# Sumter City-County Planning Commission

## SD-13-01(Rev. 1), Heritage Bay Subdivision(City)

### I. THE REQUEST

#### IV. PRELIMINARY PLAT REVIEW

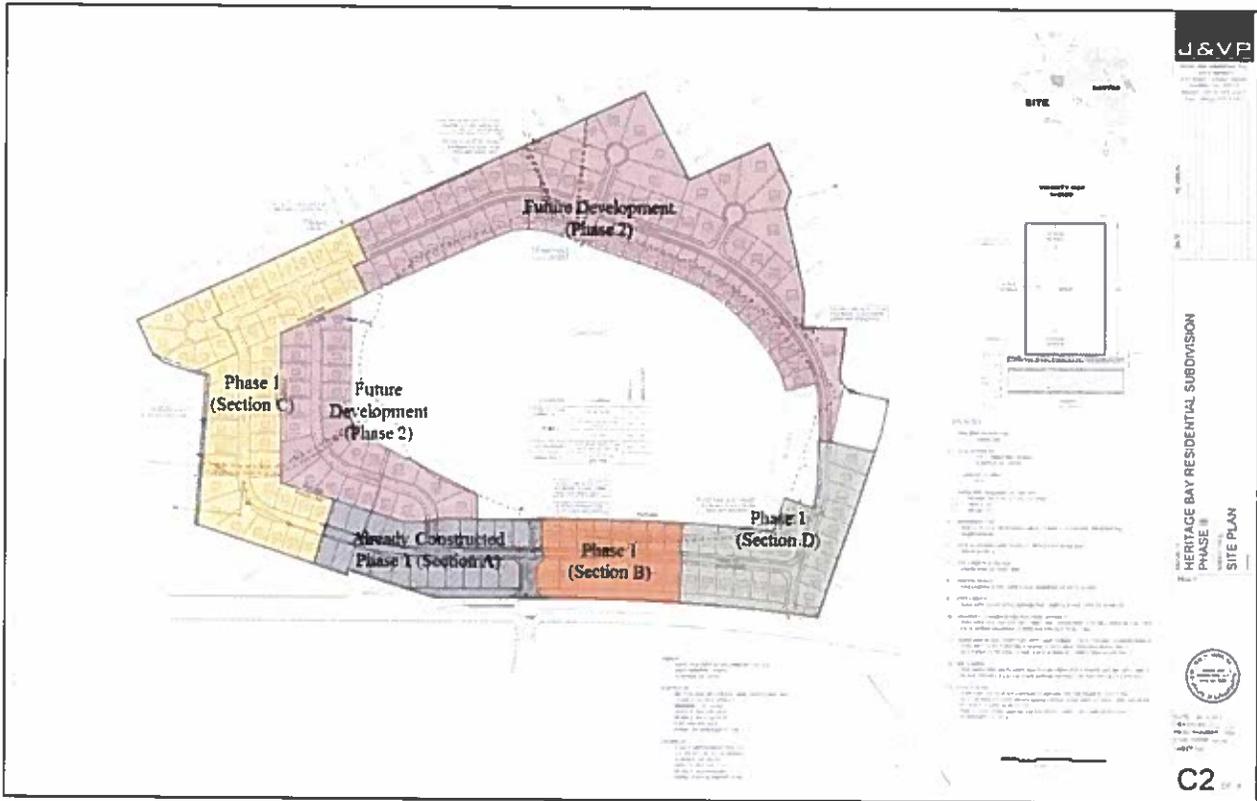
Based on Planning Staff’s understanding of the preliminary plat submission, the developer is requesting to develop this subdivision in two phases. The infrastructure for Phase 1, Section A has already been installed, received final plat approval, and is currently under construction. Phase 1 of the development has three additional areas, as shown in the graphic on the following page that are proposed for construction as part of Phase 1. Phase 2 is shown as “Future Development” with no sectioning plan in place at this time.

At full development, Phase 1 will have 96 residential lots, both primary access points on Loring Mill Rd. will be fully installed and the emergency access on Wise Dr. will also be installed. The Future Development (Phase 2) will have a total of 94 lots but all accesses into the subdivision will be in place prior to development of Phase 2.

The average proposed lot size in this development is 0.26 acres with lots ranging in size from 0.19 acres up to 0.70 acres. All lots meet the minimum lot width of 75 ft. at the minimum building line and are within the required residential width to depth ratio requirement of 1:2.5. Each parcel has enough buildable area to meet all minimum setback standards without exceeding the maximum 40% impervious surface ratio. We note for the record that several lots are irregularly shaped (lots 10, 13, 16, 46, 47, 127). We caution the developer that typical house plans may not fit on several of these lots.

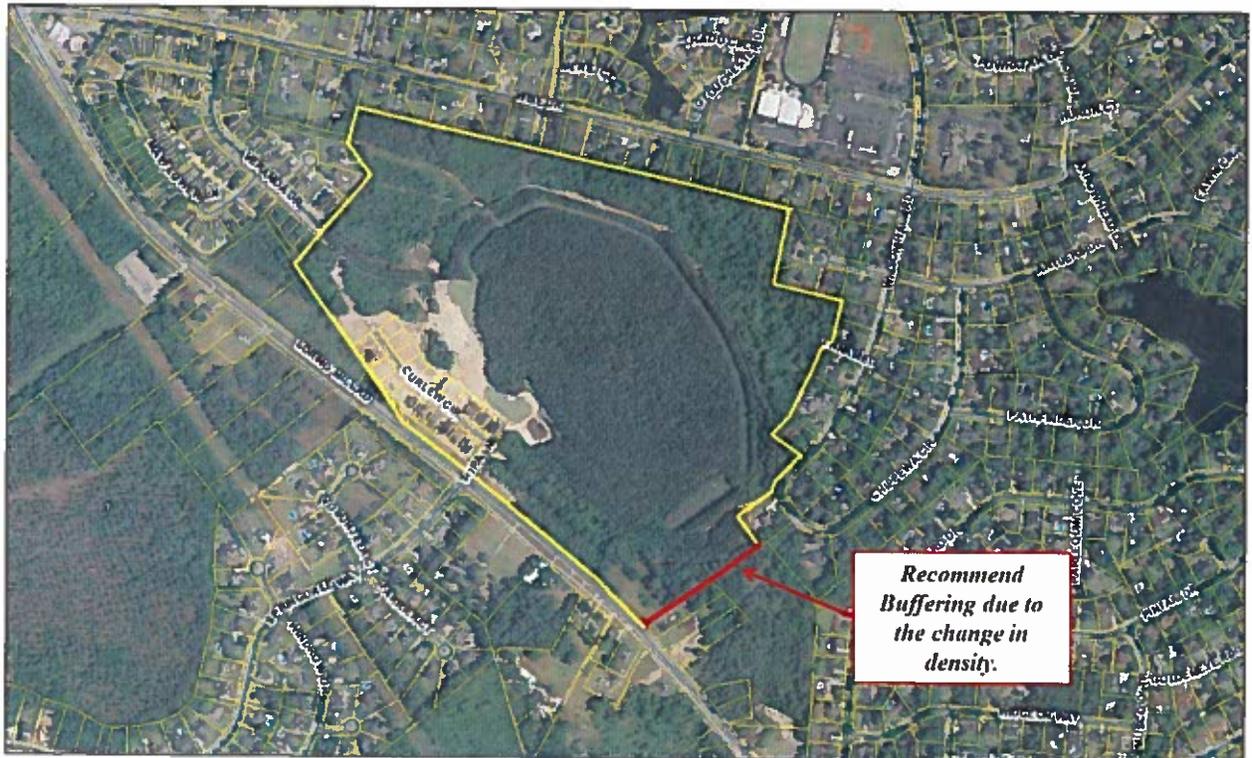
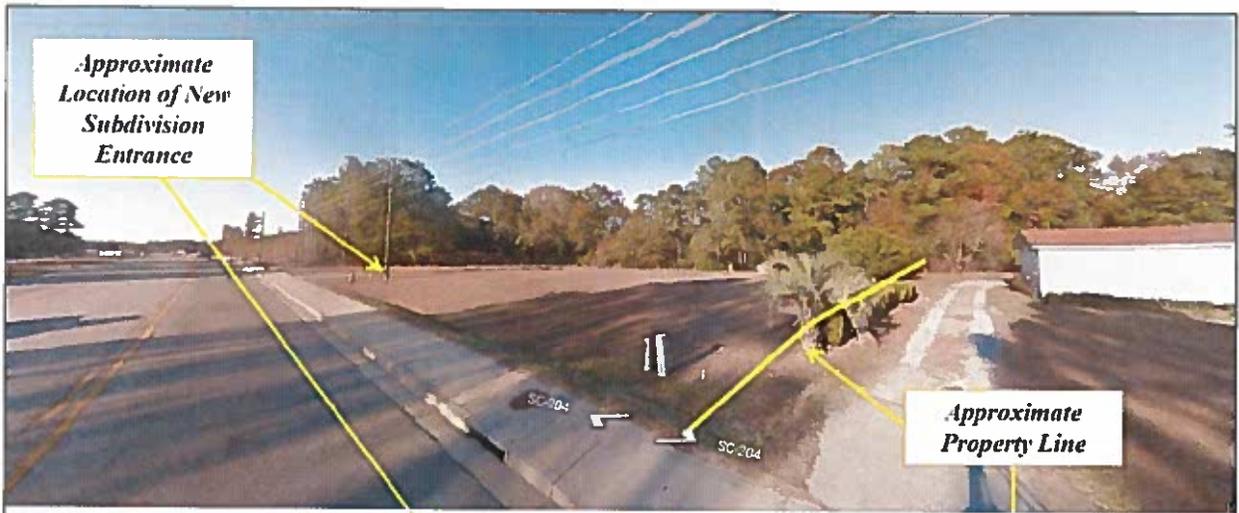
The applicant submitted a tree survey as part of preliminary review. It should be noted that no trees within the central open space were surveyed as of publication of this report as it is the intent of the developer to preserve the natural appearance of the bay. Based upon the proposed lot layout, as shown in the graphic on the following page, there are multiple lots within Phase 1 and Phase 2 with significant or historic trees on them. The lots highlighted in orange are all parcels that have significant trees either outside of the buildable area and/or on the common property lines between the two parcels which, with careful planning and dwelling selection should be able to be built upon while preserving some, if not all, of the mature trees on each lot. The parcels highlighted in red would be rendered impractical for development if the trees were preserved due to the location of the trees within the buildable areas and the sizes of each lot.

There are also significant/historic trees located in the red highlighted areas of the proposed right-of-way. The table on the following page details trees within the rights-of-way.

All trees within the right-of-way will be lost due to road construction and change in grade. The areas highlighted in red within the road rights of way will have total tree removal for installation of infrastructure.

The developer has proposed mitigation for trees removed within the right of way through the requirement to plant two trees on each parcel in addition to plantings within the community open spaces. Staff recommends a tree preservation/mitigation plan be submitted prior to land disturbance and infrastructure installation for Phase 1, Section B; Phase 1, Section C, and Phase 1, Section D. In particular, the following lots are the site of protected trees.

Additionally, there are large sections of Phase 2 that shall not be mass graded and engineering plans for these areas are required to be designed to protect the existing trees on-site. A comprehensive tree protection plan must be submitted prior to any construction permits for Future Phase 2.

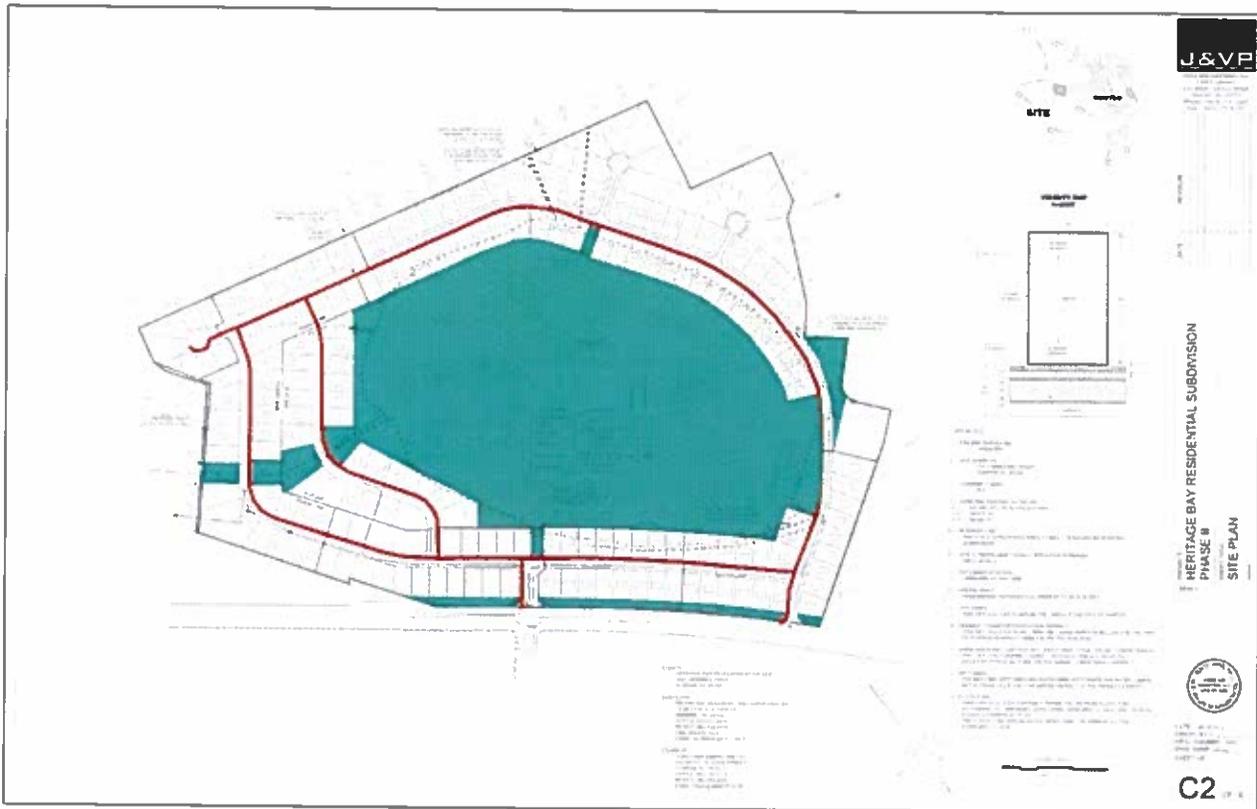
As proposed, the development will have the backyards of 5 lots abutting the common property line shared with 735 Loring Mill Rd. Due to how the existing dwelling is situated on its parcel as well as the shape of the parcel, Staff believes that some form of mitigation should be required within the areas indicated by the red line in the 2015 Orthophotography image.

Due to the limited amount of space and because this subdivision layout was under previous regulatory requirements, as well as the spacing requirements for the second full access driveway, Staff recommends installation of a 6 ft. tall privacy fence along the full length of the area indicated in red. The fence should be the same material and design through the full length of the area to be buffered.

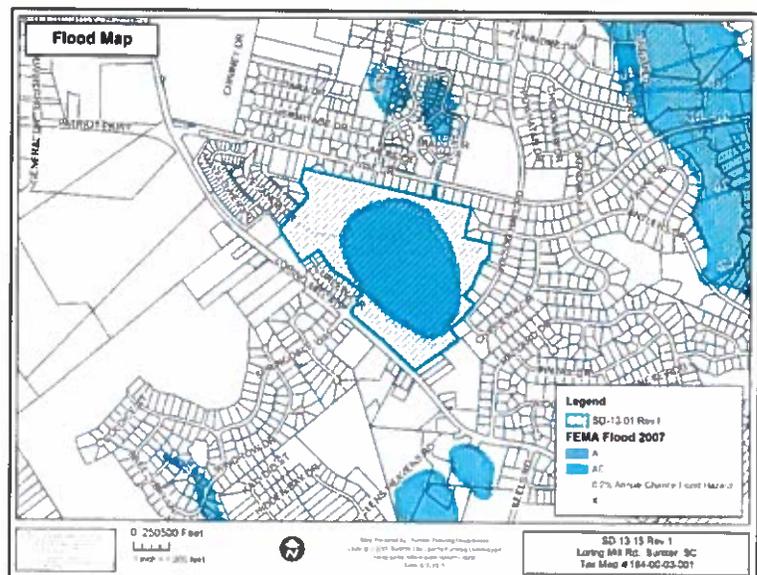
This development area is influenced by a Carolina Bay/AE Flood Zone that encompasses approximately 53 acres of the 109 acre development area. The property is shown on Firm Panel: 45085C0291d; Effective Date: 2-16-2007. The applicant submitted a Letter of Map Amendment (LOMA) to FEMA which modified the shape of the floodplain under LOMA 1-04-2299A, Effective February 11, 2014.

In accordance with the City of Sumter Flood Damage Prevention Ordinance, properties developed in a Special Flood Hazard Area (SFHA) are required to meet a higher standard of development. Properties in a SFHA may also be required to purchase mandatory flood insurance on any structures that carry a federally backed mortgage. As shown in the graphic below, there are 16 lots within Phase 1 that are influenced by the AE flood zone and 37 lots in Phase 2. In addition, areas of proposed right-of-way and sidewalks are shown within the SFHA. The base flood elevation (BFE) for this Carolina Bay is 175 ft.

The applicant has already changed the shape of the floodplain to show the true impact on the development through the LOMA process, however; due to continual changes in Federal regulations and substantial increases in flood insurance for citizens, Planning Staff recommends that no residential lots proposed within the subdivision be within any designated SFHA. This will necessitate going through the appropriate process to remove portions of the impacted lots from the floodplain through appropriate engineering by adding certified fill and satisfying the compensatory storage requirement of the Flood Damage Prevention Ordinance. Removal of lots from the flood plain can only be done by and through the approval of FEMA through the LOMR-F process.

As proposed, the Carolina Bay is being utilized for stormwater management in addition, staff recommends that the stormwater facilities be designed to meeting the requirements for and required compensatory storage for the placement of fill within the floodplain.

2. Floodplain – All proposed residential lots within the Heritage Bay Development impacted by Floodplain shall be properly engineered to be removed from the floodplain. It shall be the developer's responsibility to acquire proper approvals from FEMA to remove each proposed lot from the floodplain prior to final plat approval for said lots.
